**SUBDIVISION &  
SIDEWALK WAIVER STAFF REPORT****Date: May 5, 2016**

<b><u>NAME</u></b>	Thompson Properties C/O Bob Thompson
<b><u>SUBDIVISION NAME</u></b>	Addition to Southern Industrial Park Subdivision
<b><u>LOCATION</u></b>	5680, 5700 and 5710 Larue Steiner Road (North side of Larue Steiner Road, 370'± West of U.S. Highway 90 West).
<b><u>CITY COUNCIL DISTRICT</u></b>	District 4
<b><u>AREA OF PROPERTY</u></b>	2 Lots / 6.7 ± acres
<b><u>PRESENT ZONING</u></b>	B-3, Community Business District, and I-1, Light Industry District
<b><u>CONTEMPLATED USE</u></b>	Subdivision approval to create two legal lots of record from two legal lots of record, and Sidewalk Waiver approval to waive construction of a sidewalk along Larue Steiner Road.

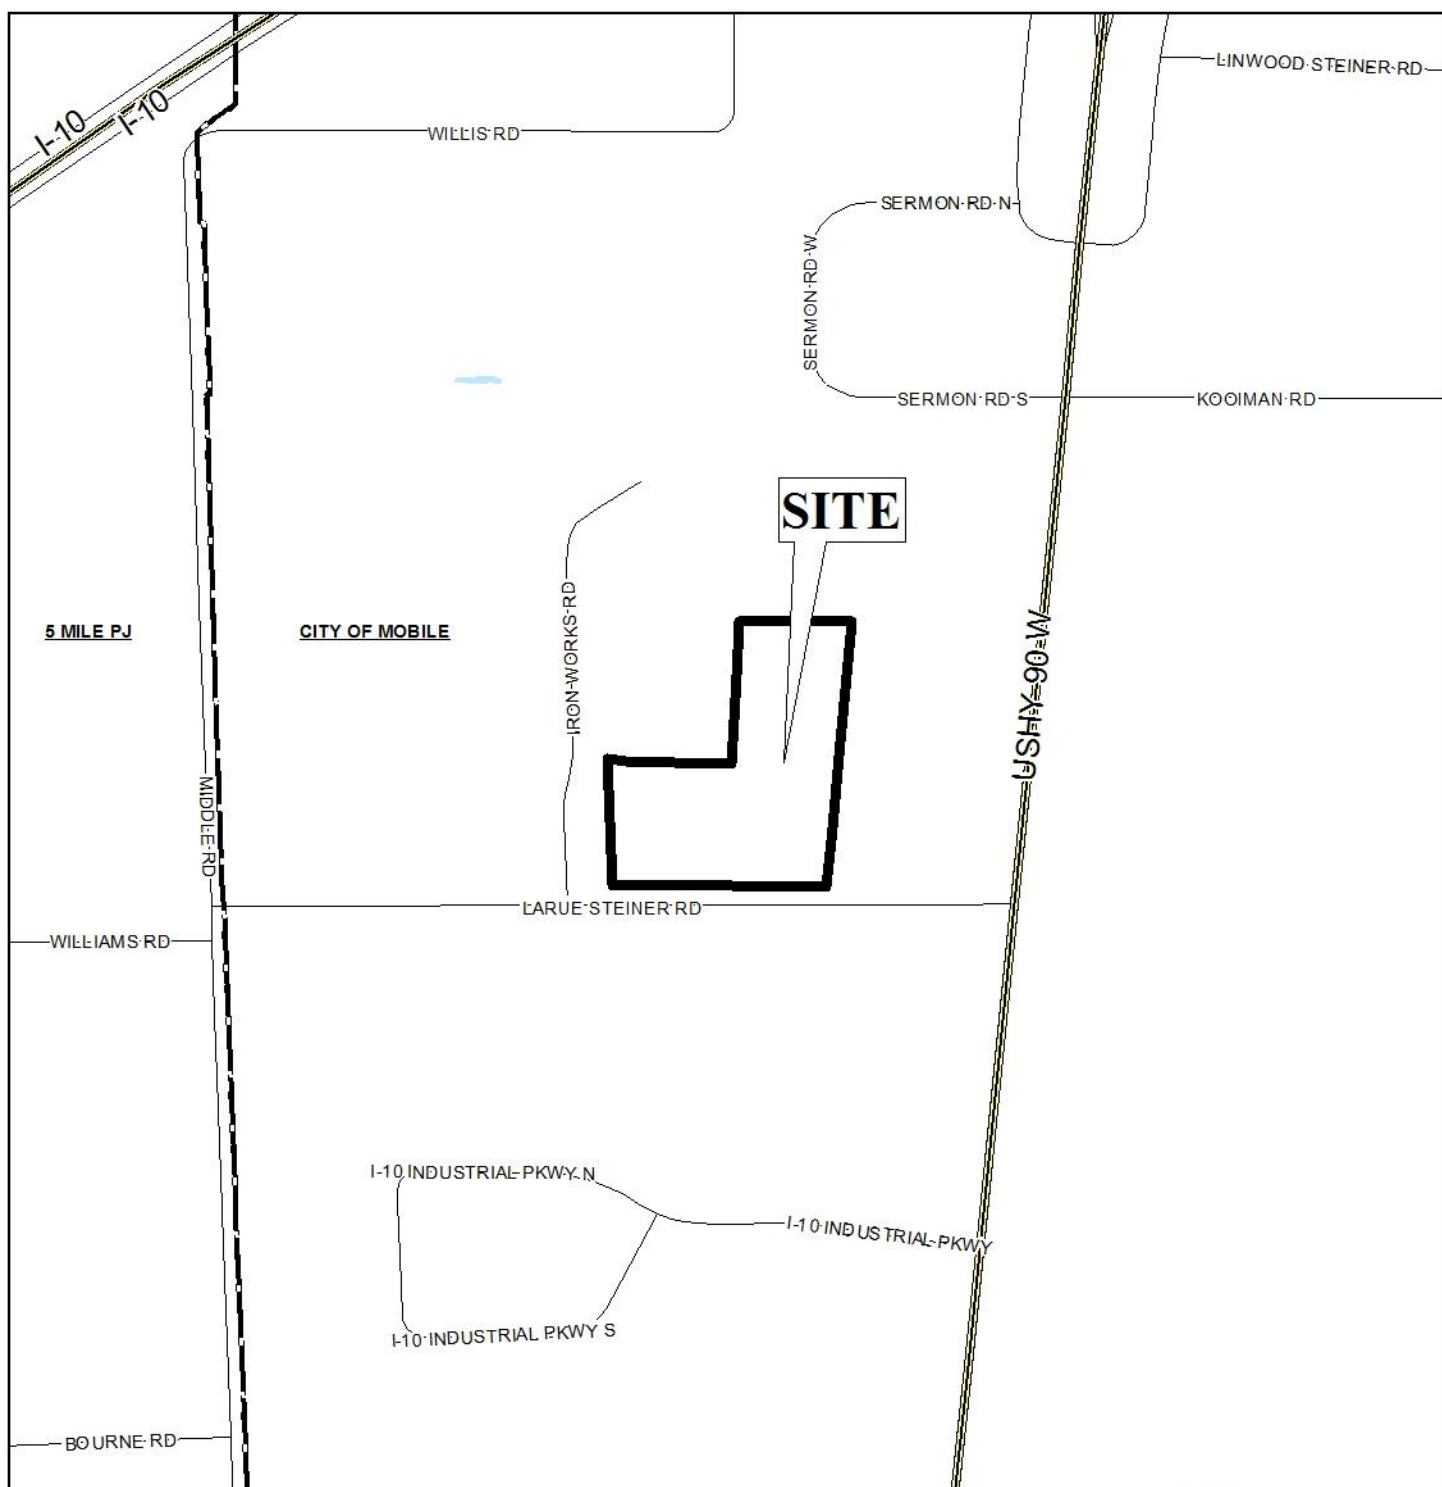
- A. Provide all of the required information on the SUBDIVISION PLAT (i.e. signature blocks, signatures, certification statements, written legal description, required notes, legend, scale, bearings and distances) that is required by the current Alabama State Board of Licensure for Professional Engineers and Land Surveyors.

- B. Revise the plat to label each lot with its size in acres and square feet, or the furnishing of a table on the Plat providing the same information.

- C. Show and label the existing Lots 1, 2, and 5 that are referenced in the written description.
- D. Show and label Iron Works Road as "PRIVATE".
- E. Show and label each and every existing drainage easement within and adjacent to the proposed subdivision.

- F. The proposed subdivision receives drainage from a public street and will require a PUBLIC (Dedicated to the City of Mobile) drainage easement; the width and alignment of the easement shall be coordinated with, and approved by, the City Engineer. The existing drainage ditch that runs through LOT 1 and LOT 2 needs to be contained in a PUBLIC DRAINAGE EASEMENT. Additional width may be required to allow vehicular and equipment access. Additionally a PUBLIC DRAINAGE EASEMENT is required along the western property line of LOT 2.

- G. Show and label the existing adjacent lot lines at the NW side of LOT 2, including existing easements.
- H. Provide and label the monument set or found at each subdivision corner.

- I. Provide the Surveyor's, Owner's (notarized), Planning Commission, and Traffic Engineering signatures.
- J. Add a note to the SUBDIVISION PLAT stating that a Land Disturbance permit will be required for any land disturbing activity in accordance with Mobile City Code, Chapter 17, Storm Water Management and Flood Control; the City of Mobile, Alabama Flood Plain Management Plan (1984); and, the Rules For Erosion and Sedimentation Control and Storm Water Runoff Control.

- K. Add a note to the SUBDIVISION PLAT stating that as shown on the 1984 aerial photo (FLIGHT 20 - #91) the Lot(s) will receive NO historical credit of impervious area towards stormwater detention requirement per Mobile City Code, Chapter 17, Storm Water Management and Flood Control.

- L. Add a note to the SUBDIVISION PLAT stating that LOT 1 and LOT 2 must provide stormwater detention for the 100 year (post-development) frequency storm event and limit the release rate to the 2 year (predevelopment) frequency storm event.

- M. Add a note to the Plat stating that the approval of all applicable federal, state, and local agencies (including all storm water runoff, wetland and floodplain requirements) will be required prior to the issuance of a Land Disturbance permit.

- N. Add a note that sidewalk is required to be constructed, and/or repaired, along the frontage of each lot, or parcel, at time of new development or construction, unless a sidewalk waiver is approved.

Proposed Lot 2 is irregularly shaped and may be regarded as a "flag" lot with a "pole" providing frontage onto Larue Steiner Road 106'± in width. Flag lots are generally discouraged by Section V.D.1. of the Subdivision Regulations. However, they are permitted only in those locations where varied and irregularly-shaped lot designs are common and the informality of design is consistent with other lots in the vicinity. For this site, the proposed new common lot line follows an existing open drainage channel, thus a waiver of Section V.D.1. may be appropriate. A note should be required on the Final Plat stating that no further re-subdivision of Lot 2 will be allowed until additional street frontage is provided.

The proposed lot sizes are not provided in either square feet or acres on the preliminary plat, and it should be noted that the width of the "pole" of the proposed "flag" Lot 2 is large enough to be potentially re-subdivided. As such, in accordance with Subdivision Regulations, the "pole" is not exclusive of unusable land, thus contributing to a maximum depth more than 3.5 times the width of the lot at the minimum building setback line; a waiver of Section V.D.3. will be required for approval. Irrespective of the width-to-depth ratio, the proposed lots exceed the minimum size requirements; but, the lots are not appropriately labeled with their sizes in square feet and acres. This information should be illustrated on the Final Plat, or a table with the same information should be provided on the Final Plat, if approved.

It should be noted that there is a 15' drainage easement illustrated along the proposed North property lines of both lots, 15' drainage easements along the proposed East property line of Lot 1, 15' drainage easements along the East and West property lines of Lot 2, and a 30' drainage easement within the proposed Lot 1. A note should be placed on the Final Plat, if approved, stating that no structures shall be erected in any easements.

- 1) placement of a note on the Final Plat stating that no further re-subdivision of Lot 2 will be allowed until additional street frontage is provided;

- 2) labeling of the lot sizes in square feet and acres, or a table with the same information provided on the Final Plat;
- 3) retention of the 25' minimum building setback line on the Final Plat;

- 4) placement of a note on the Final Plat stating that each lot is limited to one curb cut to Larue Steiner Road, with their sizes, locations, and designs to be approved by Traffic Engineering and conform to AASHTO standards;

- 5) a note stating that no structures shall be erected in any easements;
- 6) compliance with Engineering comments: *(The following comments should be addressed prior to submitting the FINAL PLAT for acceptance and signature by the City Engineer: A) Provide all of the required information on the SUBDIVISION PLAT (i.e. signature blocks, signatures, certification statements, written legal description, required notes, legend, scale, bearings and distances) that is required by the current Alabama State Board of Licensure for Professional Engineers and Land Surveyors. B) Revise the plat to label each lot with its size in acres and square feet, or the furnishing of a table on the Plat providing the same information. C) Show and label the existing Lots 1, 2, and 5 that are referenced in the written description. D) Show and label Iron Works Road as "PRIVATE". E) Show and label each and every existing drainage easement within and adjacent to the proposed subdivision. F) The proposed subdivision receives drainage from a public street and will require a PUBLIC (Dedicated to the City of Mobile) drainage easement; the width and alignment of the easement shall be coordinated with, and approved by, the City Engineer. The existing drainage ditch that runs through LOT 1 and LOT 2 needs to be contained in a PUBLIC DRAINAGE EASEMENT. Additional width may be required to allow vehicular and equipment access. Additionally a PUBLIC DRAINAGE EASEMENT is required along the western property line of LOT 2. G) Show and label the existing adjacent lot lines at the NW side of LOT 2, including existing easements. H) Provide and label the monument set or found at each subdivision corner. I) Provide the Surveyor's, Owner's (notarized), Planning Commission, and Traffic Engineering signatures. J) Add a note to the SUBDIVISION PLAT stating that a Land Disturbance permit will be required for any land disturbing activity in accordance with Mobile City Code, Chapter 17, Storm Water Management and Flood Control; the City of Mobile, Alabama Flood Plain Management Plan (1984); and, the Rules For Erosion and Sedimentation Control and Storm Water Runoff Control. K) Add a note to the SUBDIVISION PLAT stating that as shown on the 1984 aerial photo (FLIGHT 20 - #91) the Lot(s) will receive NO historical credit of impervious area towards stormwater detention requirement per Mobile City Code, Chapter 17, Storm Water Management and Flood Control. L) Add a note to the SUBDIVISION PLAT stating that LOT 1 and LOT 2*

## SECTION WEST OF DRIVE

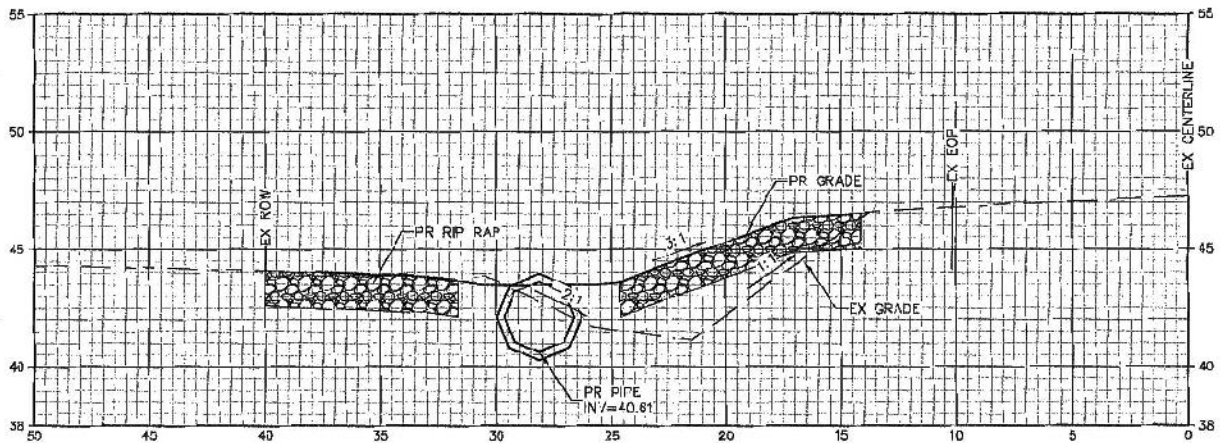
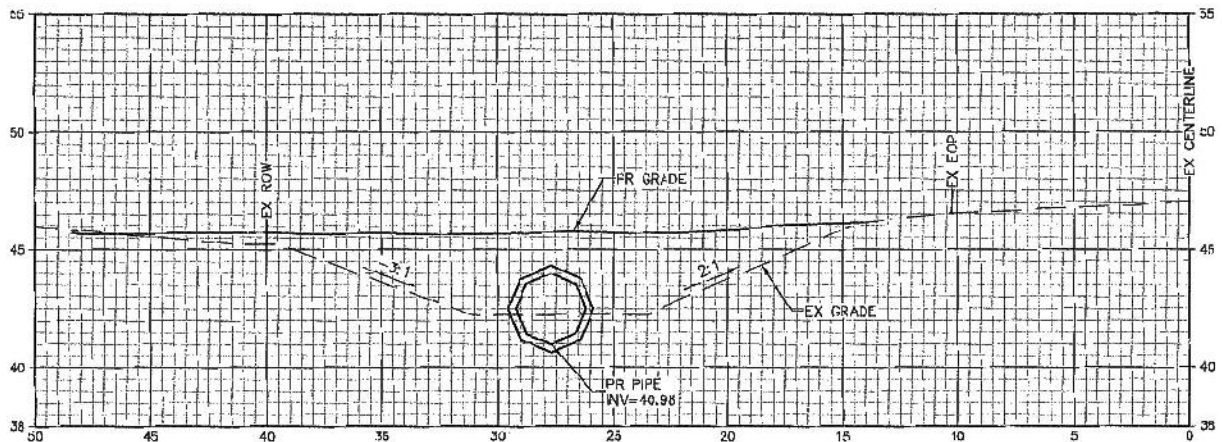
*“THIS PROPERTY IS ZONED I-1 AND IS AN OPEN DITCH SECTION WITH VERY STEEP SECTIONS BEING 1:1 SLOPES IN MOST AREAS. THERE IS A MAJOR CROSSDRAIN THROUGH THIS PROPERTY THAT MAKES IT IMPOSSIBLE FOR WALKING TRAFFIC TO THE WEST. ALSO THIS IS LOCATED NEXT TO TRACTOR SUPPLY WHICH HAS OBTAINED A VARIANCE OF SIDEWALKS AS WELL. THE SIDEWALK IS NOT IN LINE WITH THE SURROUNDING INDUSTRIAL USES AND WOULD NOT BE BENEFICIAL FOR WALKING TRAFFIC AS IT LEADS TO THIS MAJOR CROSS DRAIN. THE CONSTRUCTION OF THE SIDEWALK DOES NOT ALLOW FOR A CONSTRUCTION THAT IS SUITABLE FOR THIS DEVELOPMENT OR ADJACENT PROPERTIES.”*

Larue Steiner Road has a two lane cross-section at this location and is characteristic of an open ditch roadway. There are currently no sidewalks along either side of the street; however, it should be taken into consideration that the proposed development of the site may generate an increase in pedestrian and automotive traffic. Furthermore, while the site may be industrially zoned, there are several sites in the immediate vicinity that are commercially zoned yet undeveloped. As these neighboring sites are developed or re-developed, sidewalks will be required.

Because the area is primarily industrially developed, and Map for Mobile indicates this to be an industrial development area, it would appear that pedestrian traffic in the vicinity is minimal and would not likely increase due to the inherent conditions of such development; this is perhaps reinforced by the waiver of a sidewalk at a neighboring commercial development by the Planning Commission at its December 16, 2010 meeting. Also, because Larue Steiner Road is lined with open ditches, the topography at the shoulder of the road does not lend itself to a sidewalk. Given such conditions, a waiver of the construction of the sidewalk along Larue

**Sidewalk Waiver:** Due to the industrial zoning and the size of the existing roadside drainage ditch it is recommended that this request be approved.

**Sidewalk Waiver:** Based upon the preceding, this application for waiver of the sidewalk along Larue Steiner Road is recommended for approval; however future development or re-development of Lot 1 will necessitate a new application.
